Kennebec Valley Community College 92 Western Avenue Fairfield, ME 04937

Competitive Bid Request for Proposal Exterior Building Signage

Addendum II October 26, 2022

Carter Hal

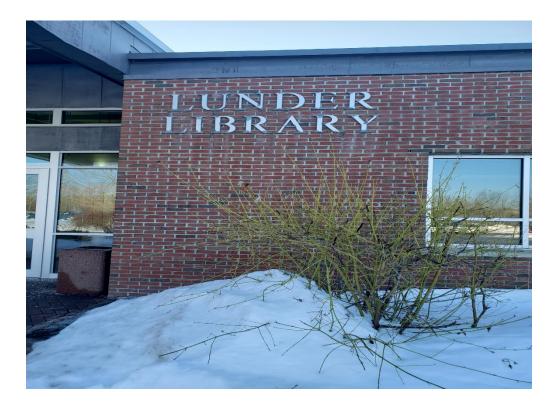
Share the pictures of the Building where the Signs are installed and will be removed.

Share the picture of the Buildings where the new signs will be installed.

Reply I

See photos in Reply I as locations are the same.
